LBNF CAD check

A crosscheck of the LBNF CAD model (ST1294927_01, August 2020) is done to verify if the changes described in document EDMS 2194738 have been implemented: <https://edms.cern.ch/document/2194738/>

8. Warm Membrane Clamps

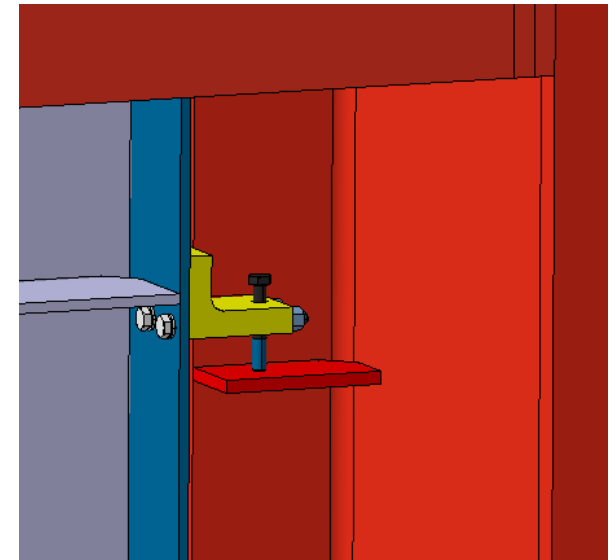
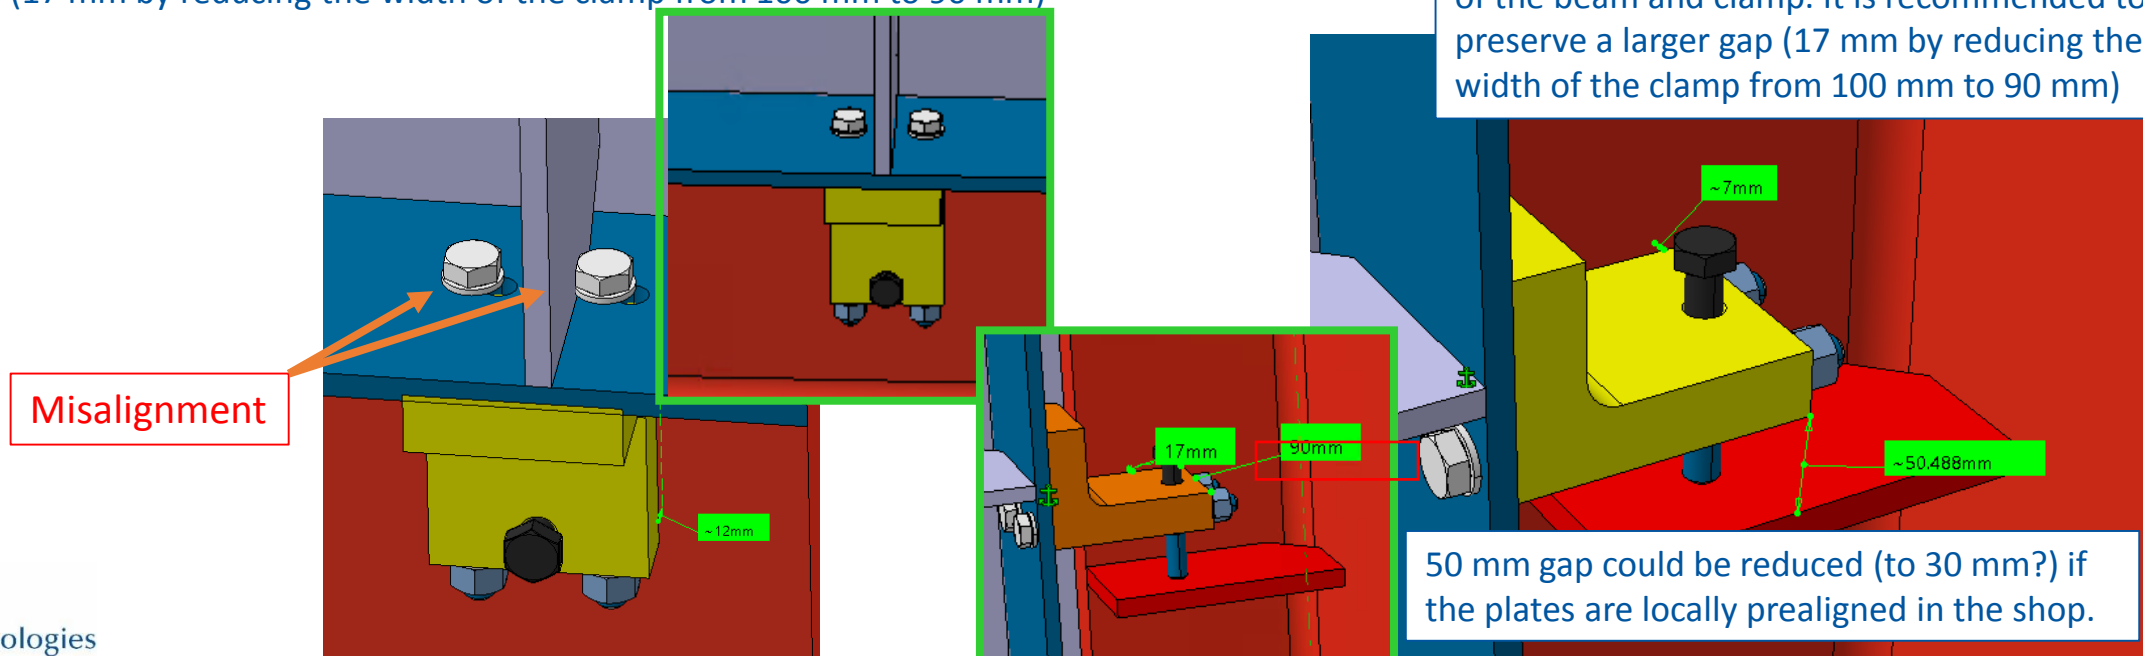
- The holes for all the clamps seems to be present, in the correct position, but not all clamps are populated in the model → **OK!**
- Some clamps are not correctly aligned with the holes → **Check alignment**
- The vertical clamps are supported on small welded plates instead of stiffeners of the beams as assumed in previously analyzed → **Conceptually OK!**
- There is a gap of 50 mm between the vertical clamps and the supporting plates. The plates can be pre-aligned in the shop to account for the dimension tolerances of the beams → **Therefore the gap between the clamp and the plate could therefore be reduced for example from 50 mm to 30 mm**
- There is only 7 mm gap only between flange of the beam and clamp. It is recommended to preserve a larger gap (17 mm by reducing the width of the clamp from 100 mm to 90 mm)

There is only 7 mm gap only between flange of the beam and clamp. It is recommended to preserve a larger gap (17 mm by reducing the width of the clamp from 100 mm to 90 mm)

50 mm gap could be reduced (to 30 mm?) if the plates are locally prealigned in the shop.

11. Backing plate

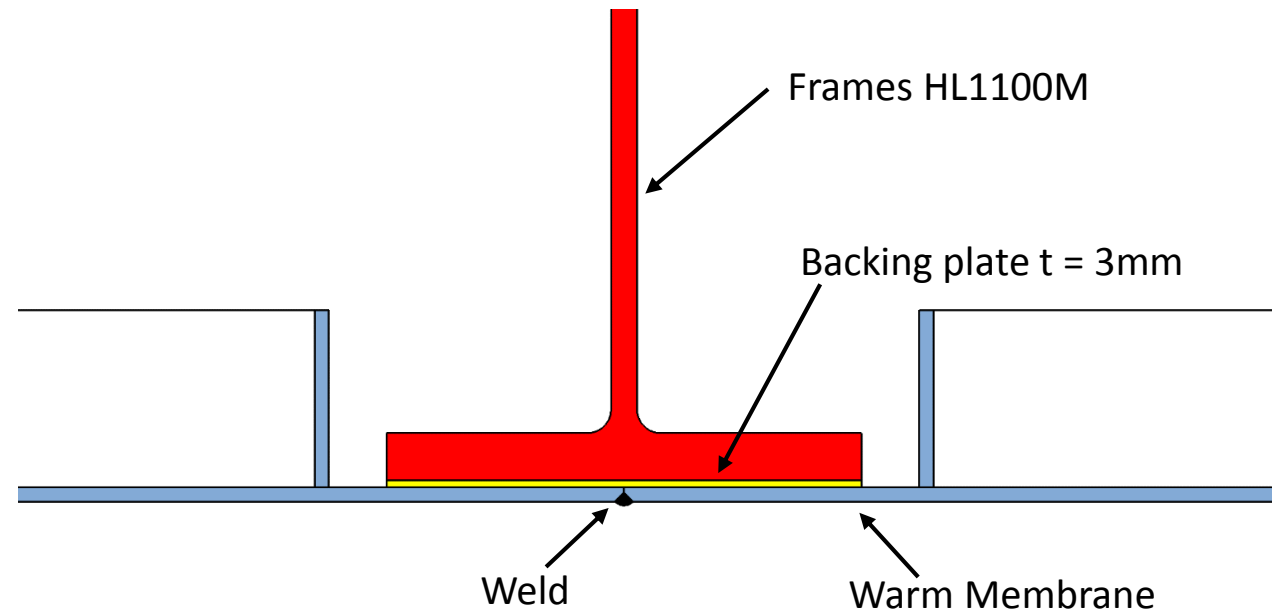
- A backing plate is introduced between the HL1100M frames and the warm membrane for welding purposes, and to avoid fusing the frame to the membrane during welding.
- A gap for 3 mm thick gap for the backing plate is left between the frame and the membrane.
It is recommended to do a welding test to see if the thickness is sufficient.

12. EP/DT Vs Neutrino team CAD model: comparison by Christophe

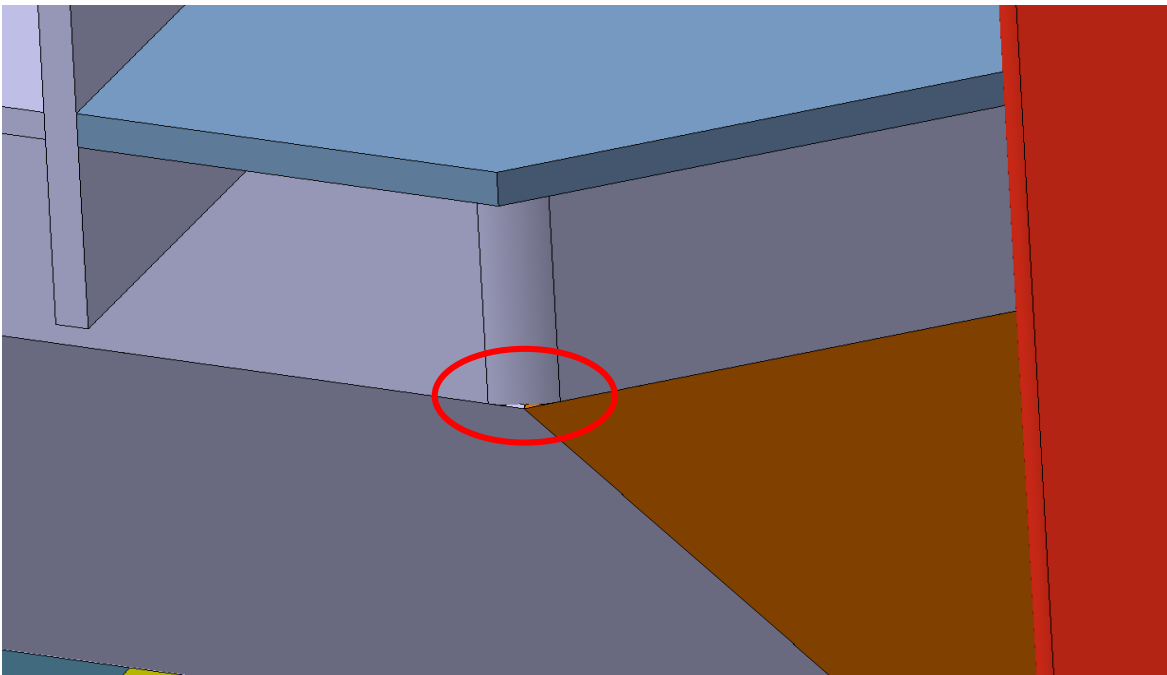
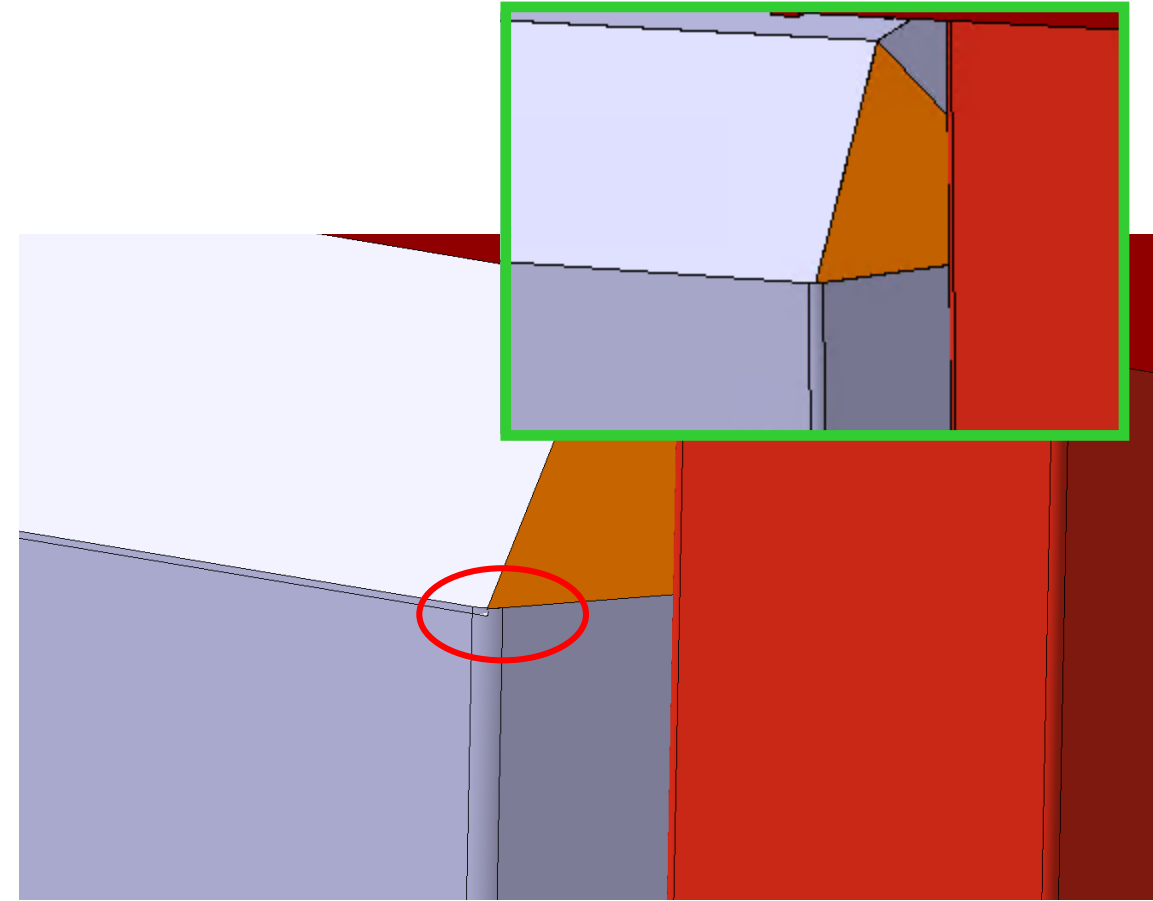
1. Warm membrane: connection in corners (side/side/top or side/side/bottom) → **to be reworked**

2. Door for detector insertion, IPE replaced by ribbed plates:

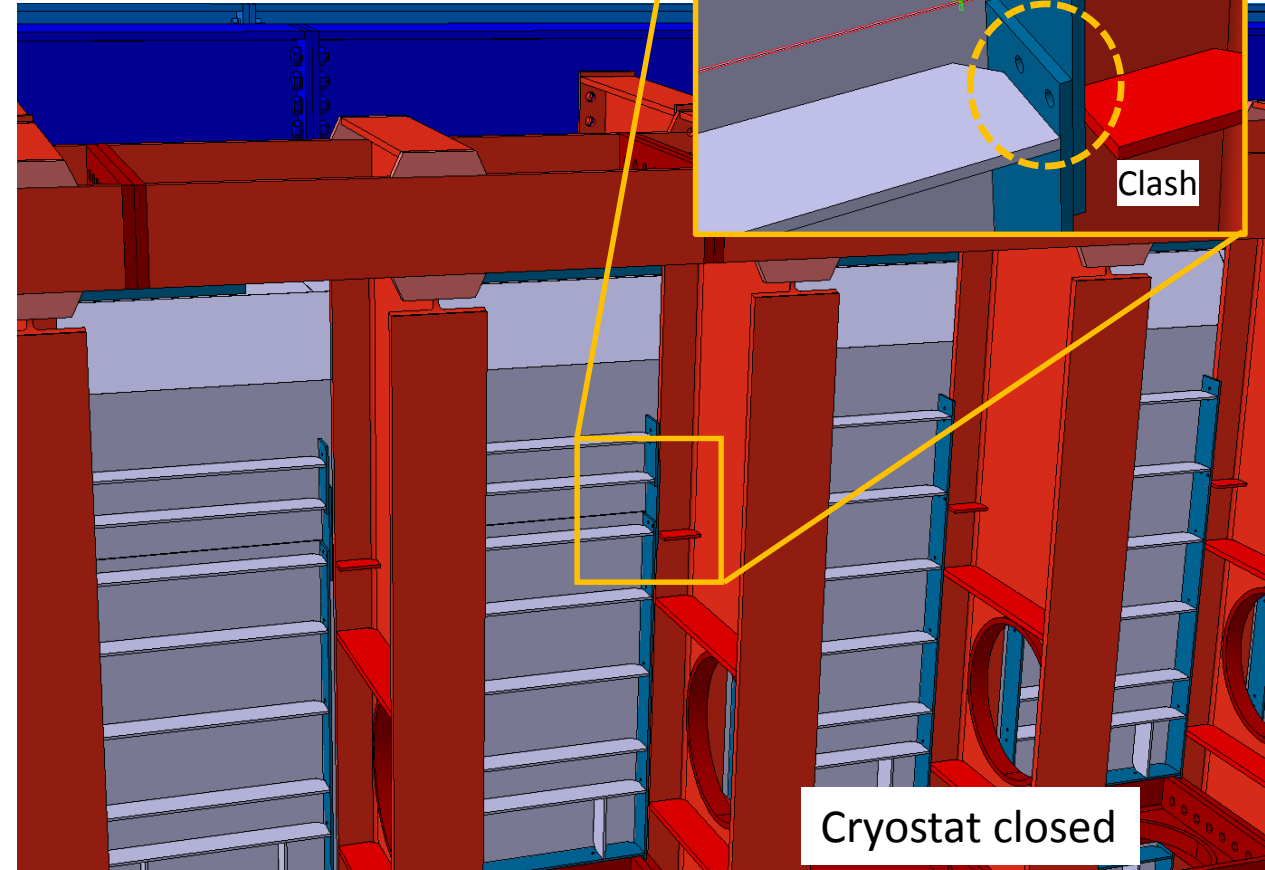
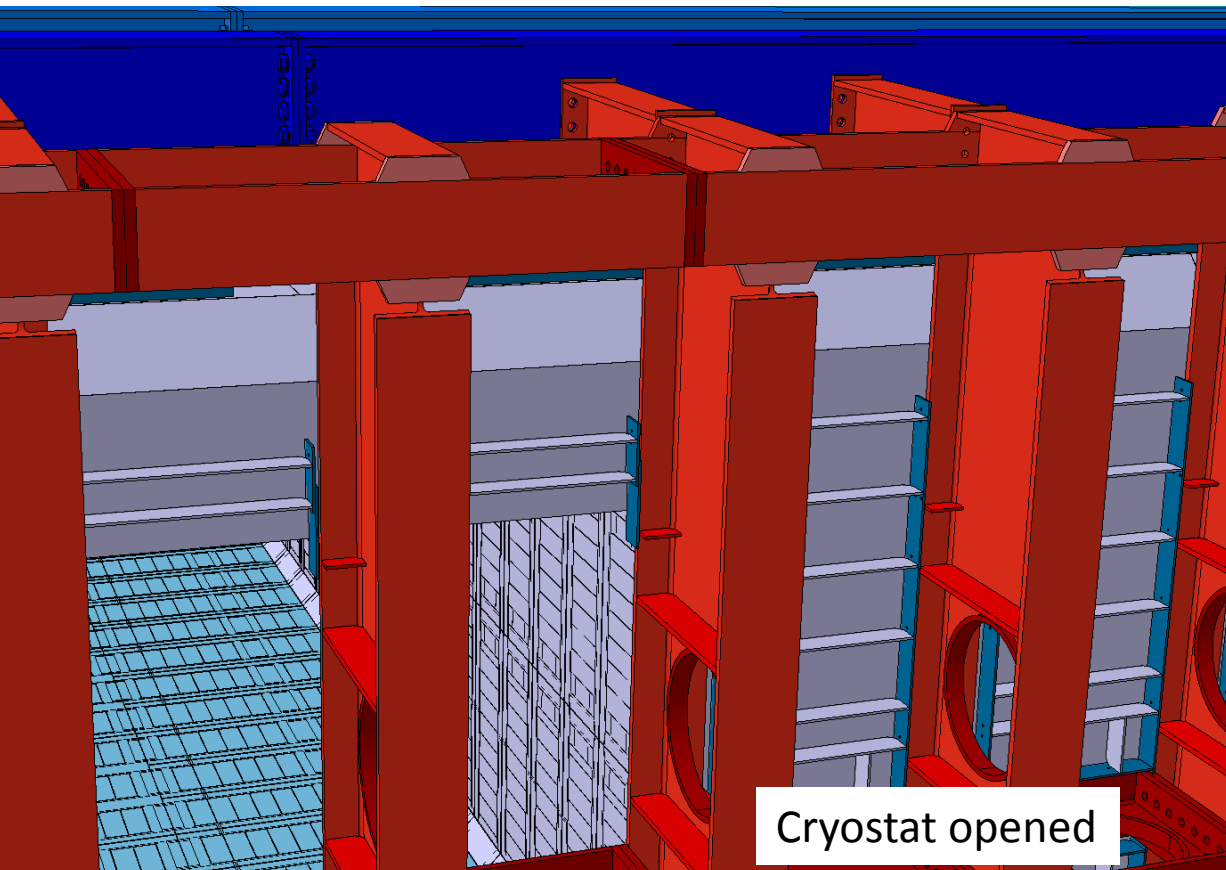
- Clamps (for vertical support and others): **Position and quantity of clamps to be adjusted for the membrane door.**
- Misalignment of membrane door plates **to be checked**

12. EP/DT Vs Neutrino team CAD model: comparison by Christophe

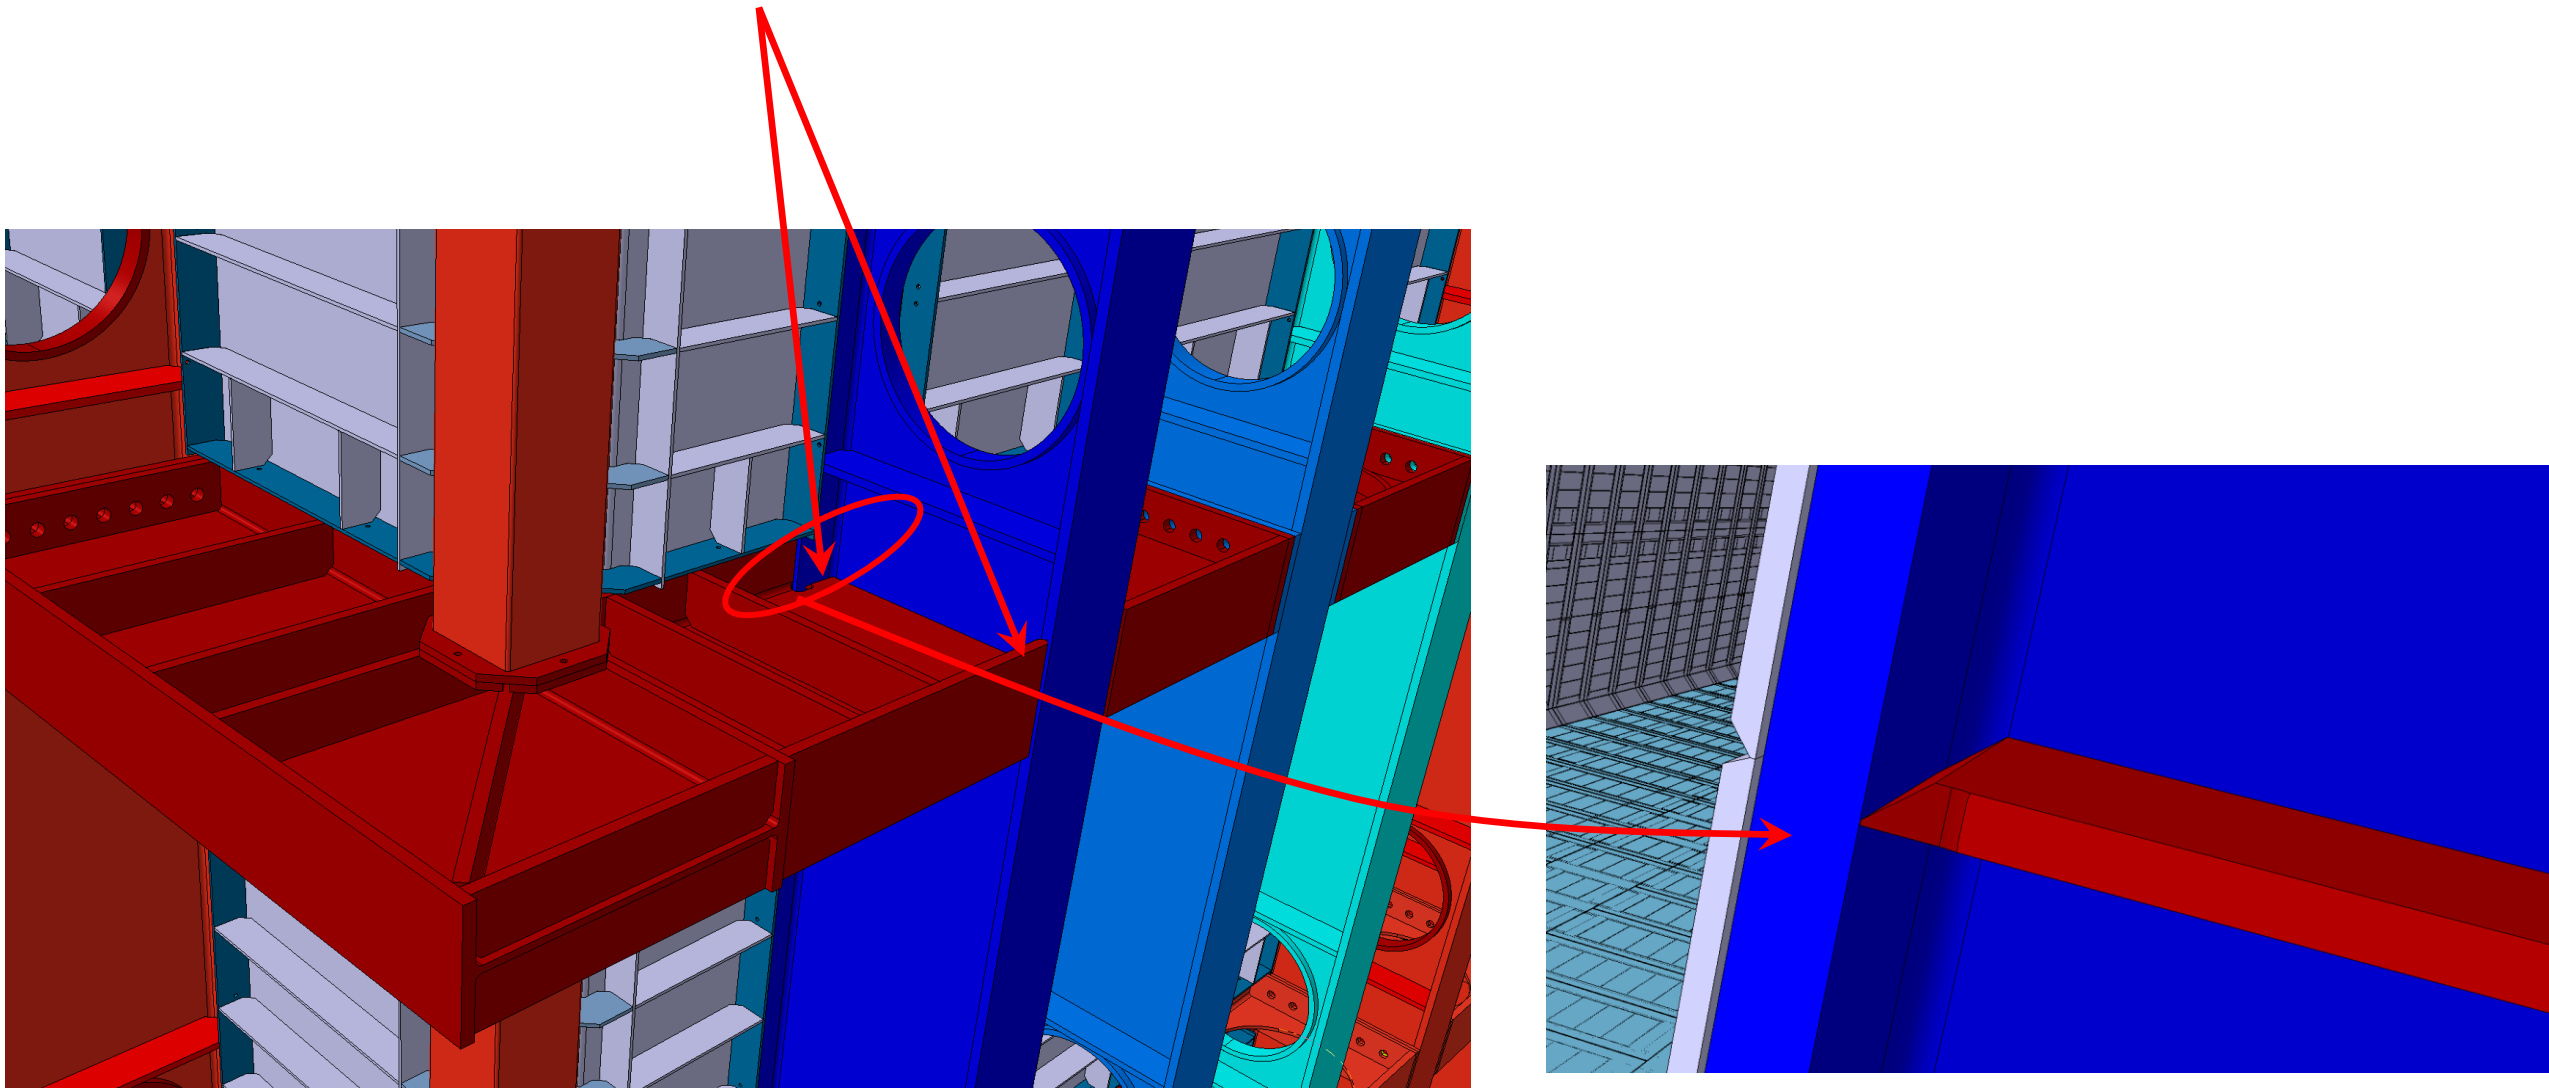
Note: No clash, but also no gap between blue vertical beam and red corner beam in chamfer region. Probably needs in situ adjustment
